## ADDENDUM NO. 2

Reference: CUCF Perimeter Security System Upgrade  
Gunnison, Utah

Project No.10208100

**CENTRAL UTAH CORRECTIONAL FACILITY  
PERIMETER SECURITY DETECTION SYSTEM**

ADD2-SK-1

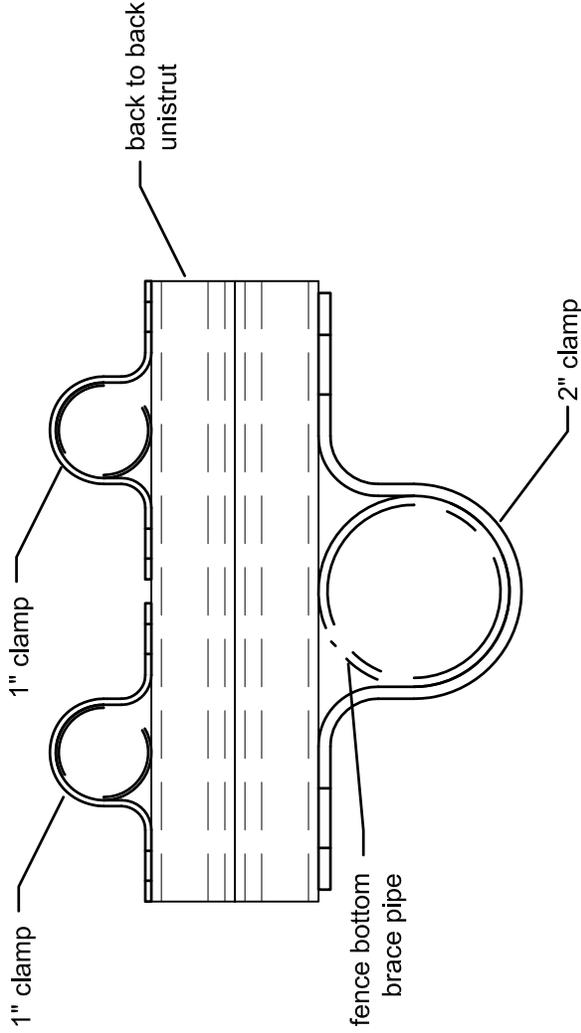
6. How exactly will the conduit be mounted to the fence posts? Will we need to weld unistrut to the pole vertically? Will we be able to use large self drilling screws to mount the unistrut?

*Response: See sketch Addendum #2 attached to the end of this Addendum.*

Provide clamps at each end and approximate center of each brace rail section  
 Bolt unistrut to brace pipe  
 Bolt conduit to unistrut  
 Unistrut and mounting clamps to be galvanized, hardware to be stainless steel
